Case # EH-PLANS-24-0
Type EnvHealth/Environmental Health/Plan Check/Application
Status In Review
Opened Date 02/29/2024
Application Name B24000587
Description SFD/ INSTALL 30' X 15' INGROUND CONCRETE SWIMMING POOL, DEPTH

Assigned to Department Well and Septic Progr
Assigned to Staff Zack Silvast

ONSITE SEWAGE
DISPOSAL AREA

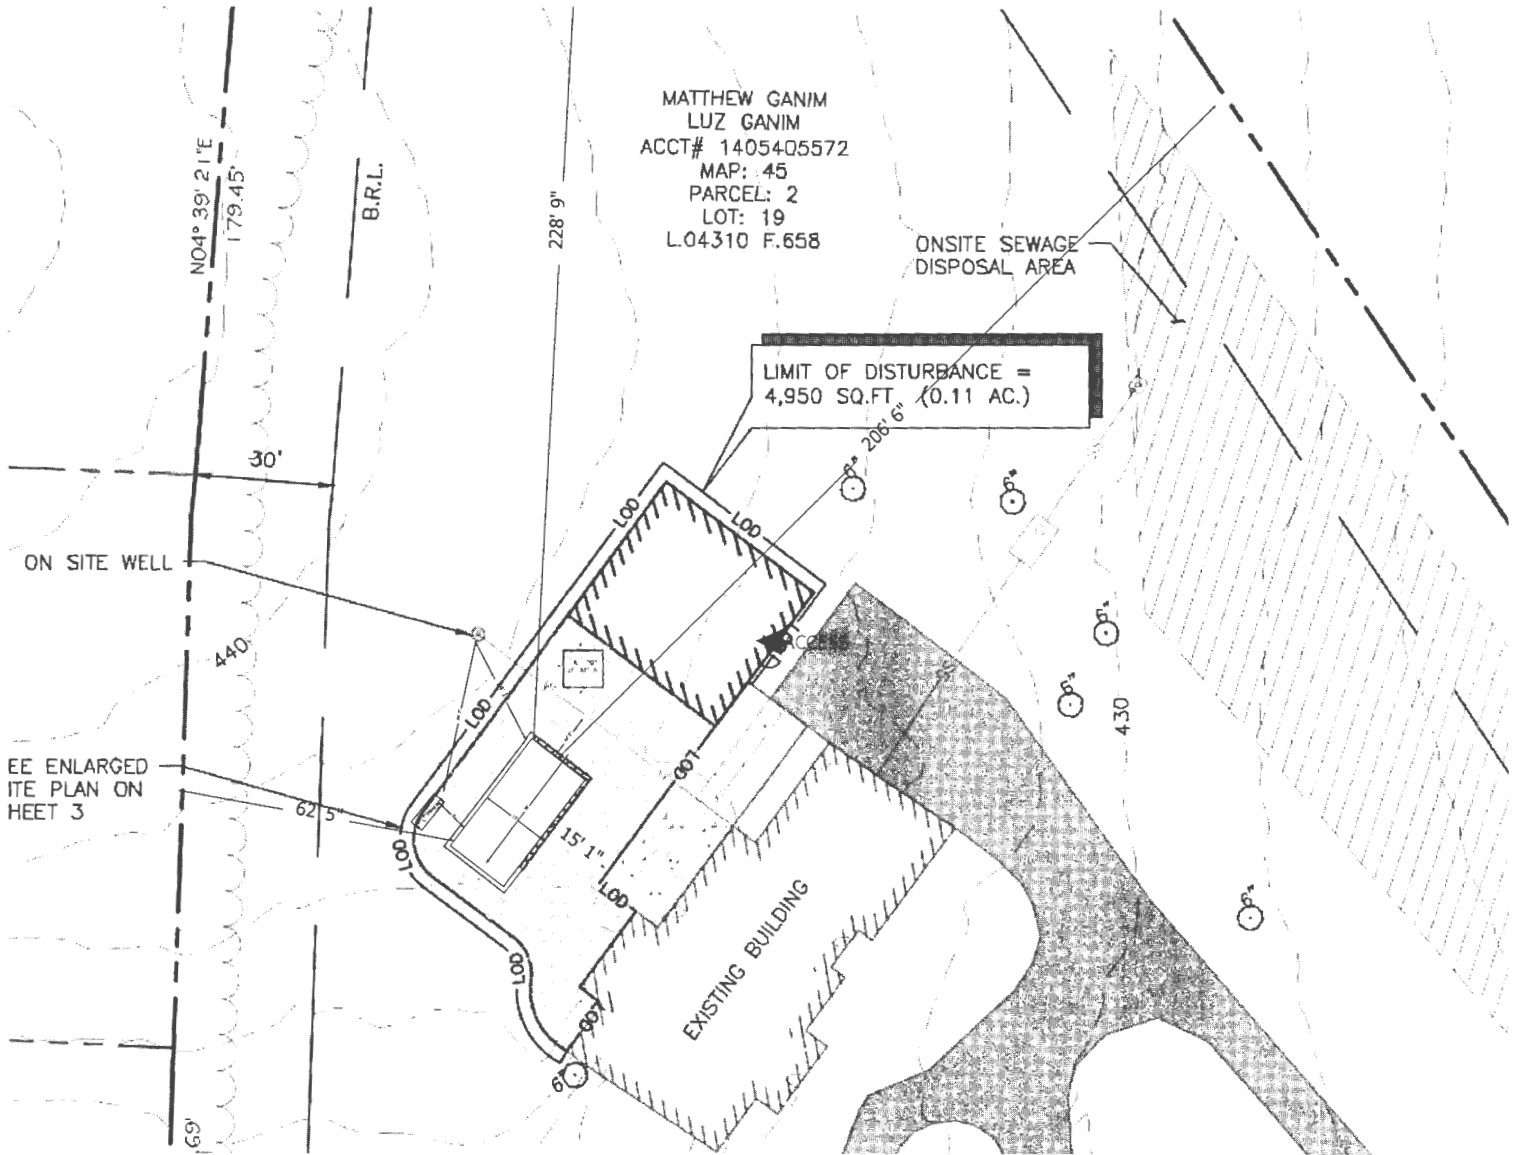
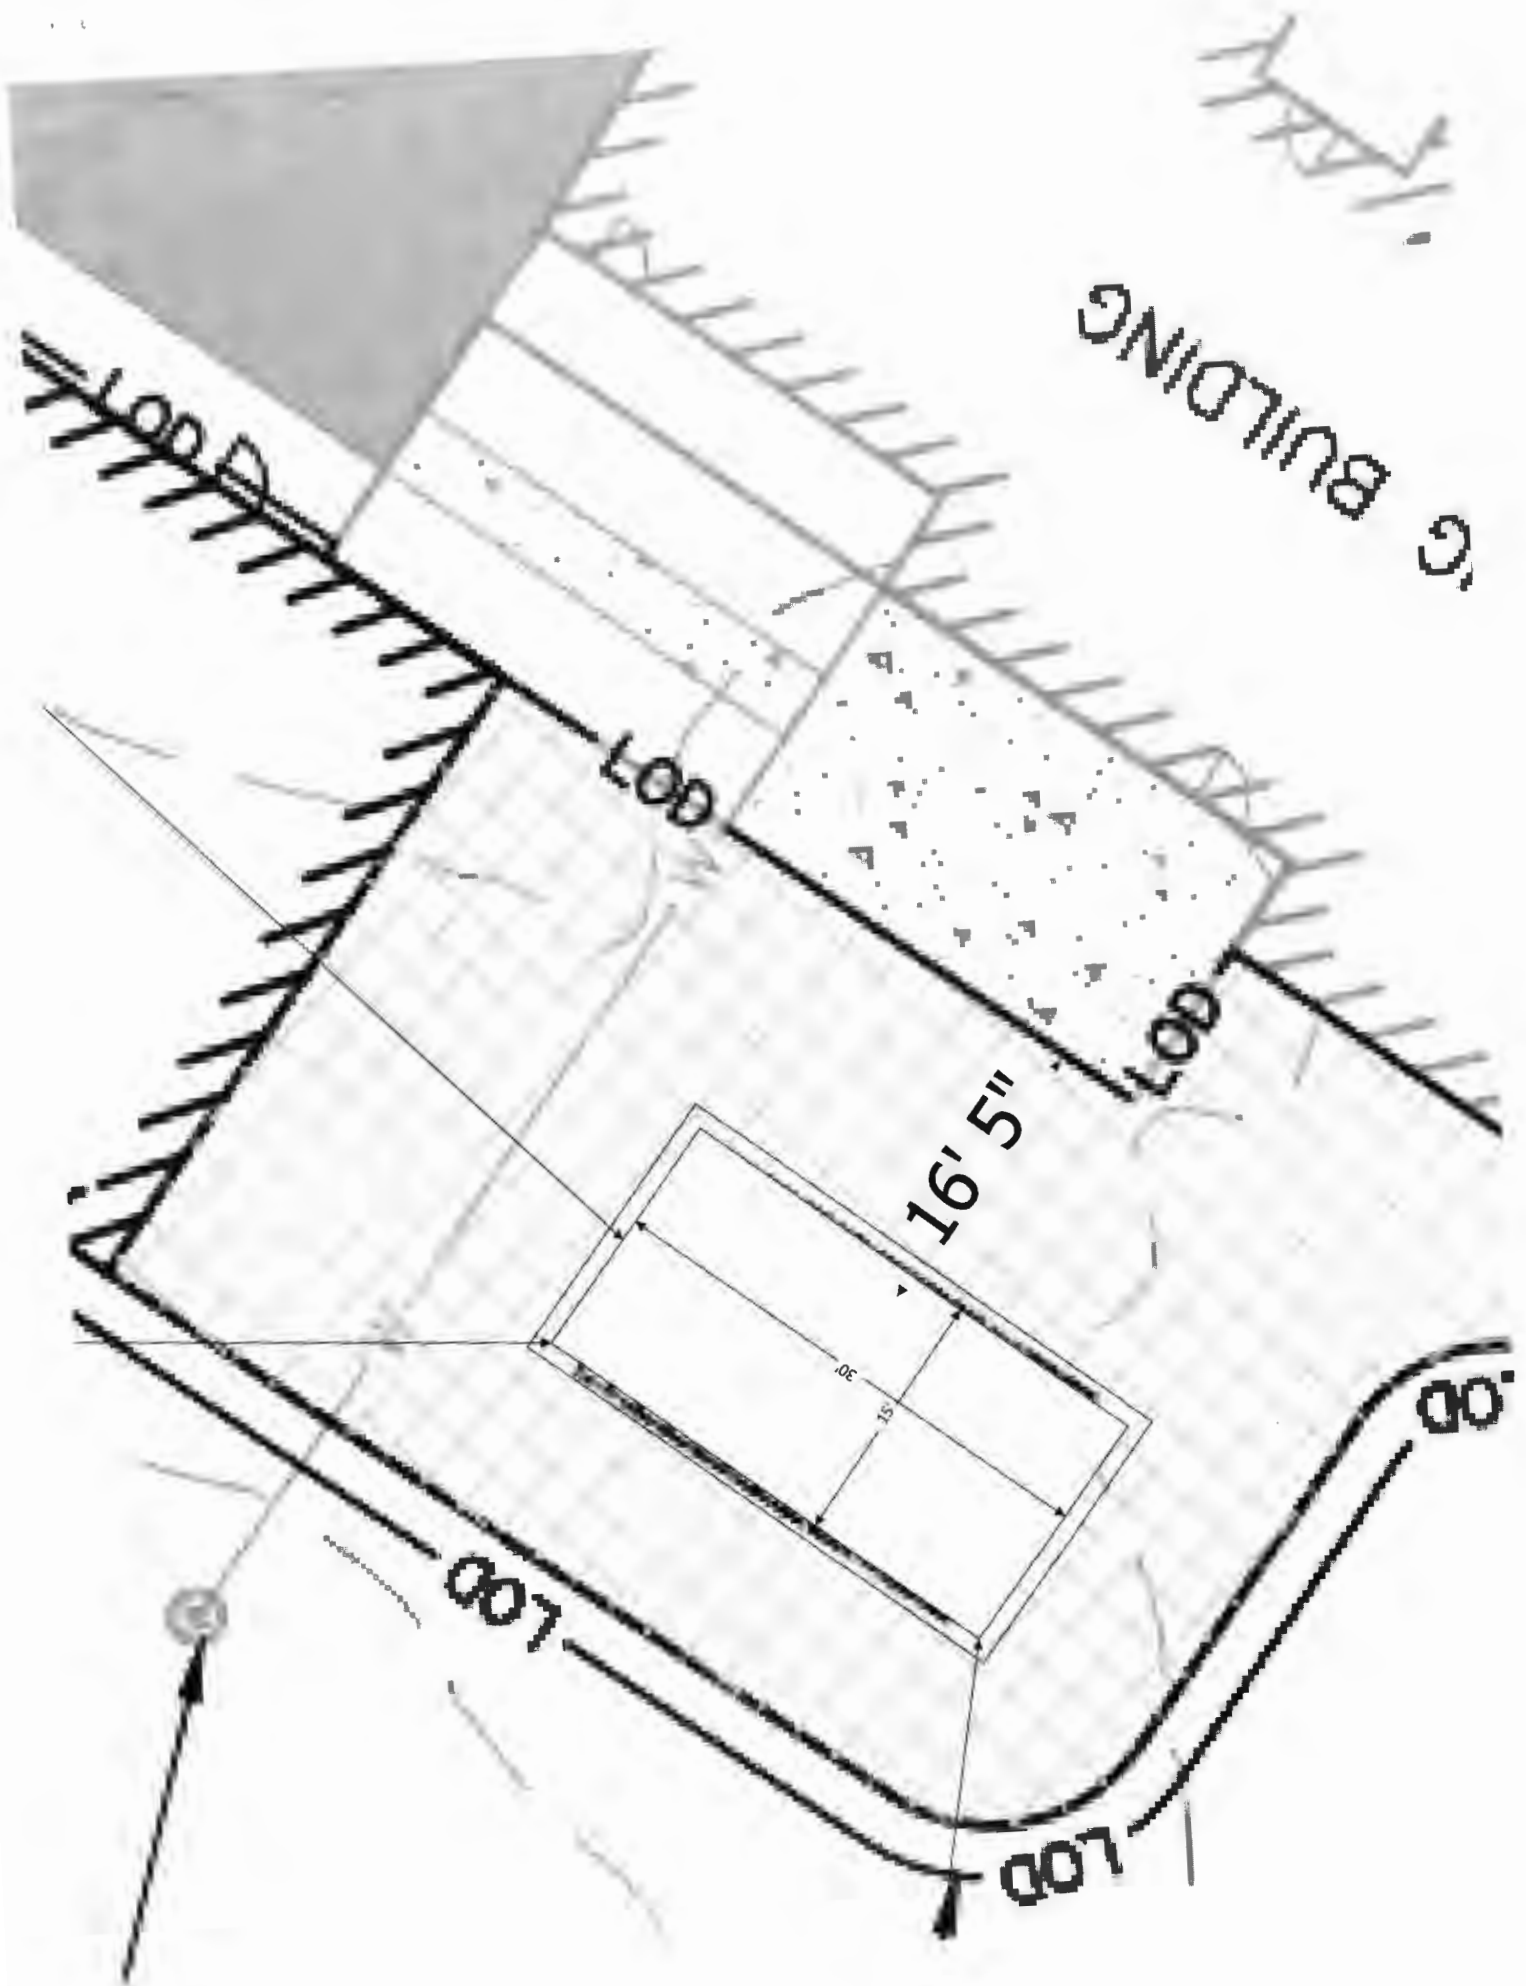
REMARKS: 7/29/97 TRENCH ③ RUNNING DOWNHILL (L.I.D) DUE TO
INSTALLER UNCERTAINTY; OK TO MAINTAIN SINCE TRENCH
SHORT, GROUND NEARLY FLAT; ALSO ADVISED INSTALLER OF
GENERAL HO CO PREFERENCES ON DESIGN, INSPECTIONS, ETC.
OK TO COVER S.T. & TRENCHES, CALL FOR HOUSE CONN INSP. (MR)

11/18/97 House connection made - OK to cover ACM
